CLA Engineers, Inc.

RE: Inland Wetland Application 24 IWC 7
339 Chesterfield Road Site Development
CLA-7873

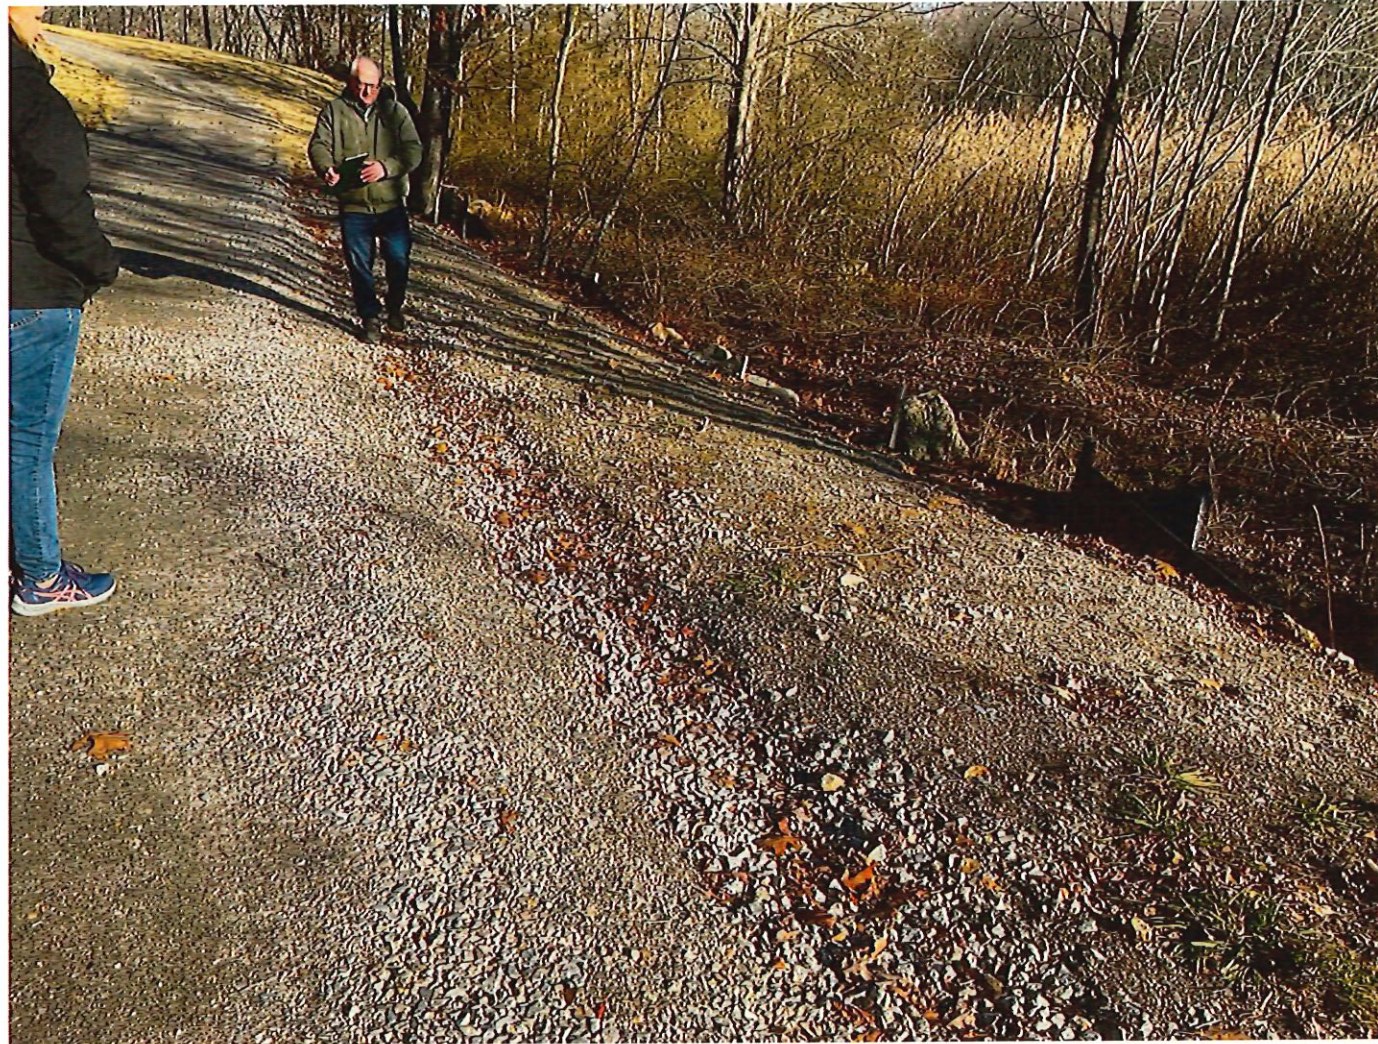
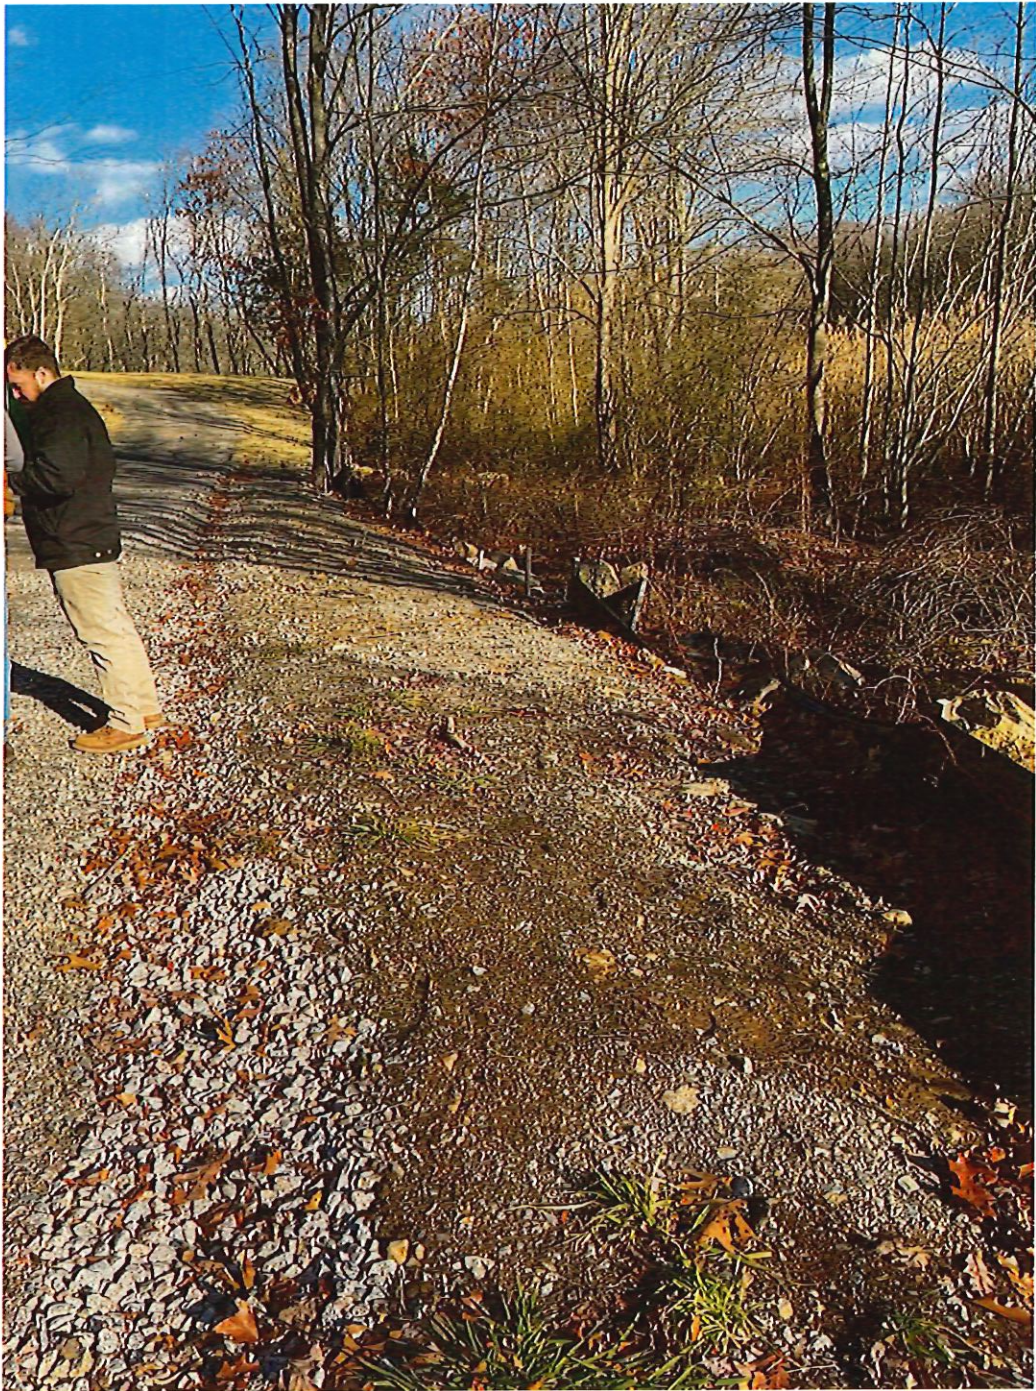
1. The stone walls along Chesterfield Rd were not on the approved plan and are partially in the upland review zone (URZ).
2. The area disturbed by the demolition of the house was not properly re-seeded with the seedmix specified on the plans.

3. The stone walls at the wetland crossing were shown not on the approved plan
4. There was stone placed in the wetland at the crossing that was not on the approved plan

5. The travel way at the wetland crossing was not constructed per plan. It is not at the proper elevation, and the travel surface is not 15 feet wide as required by zoning code and there is insufficient cover over the culverts.

6. The culvert invert elevations are off by 0.4 to 0.5 feet (too high)
7. The driveway was not built per the location as shown on the plan and some unpermitted wetland fill occurred due to this.

8. A wetland area of south of the stone diaphragm was filled without permission. The stone diaphragm was supposed to be just along the edge of the wetland with no fill in the wetland.

A markup of the as built plan is included to clarify the locations of the various violations and issues. CLA makes the following recommendations regarding items 1-8 above.

1. The walls have not resulted in wetland impacts, and they are at the outer edge of the URZ. The Commission may wish to allow the owner to apply retroactively for these walls.

2. CLA recommends that the owner have the area of the former house seeded with the proper mix this spring. Note that this area was not meant to be lawn.

3. CLA recommends that the stonewalls be removed.
4. CLA recommends that the stone placed in the wetland be removed.
5. CLA understands that the Commission does not regulate driveway width and cover over culverts, however that the driveway should be built per zoning codes and at the proper elevation and any alterations may further affect wetlands and require permitting.

6. CLA recommends that the design engineer analyze the crossing as constructed and offer an opinion as to whether the culverts should be re-set at the proper elevation.

7. CLA recommends that the fill be removed and the wetland restored.
8. CLA recommends that the fill be removed and the wetland restored.
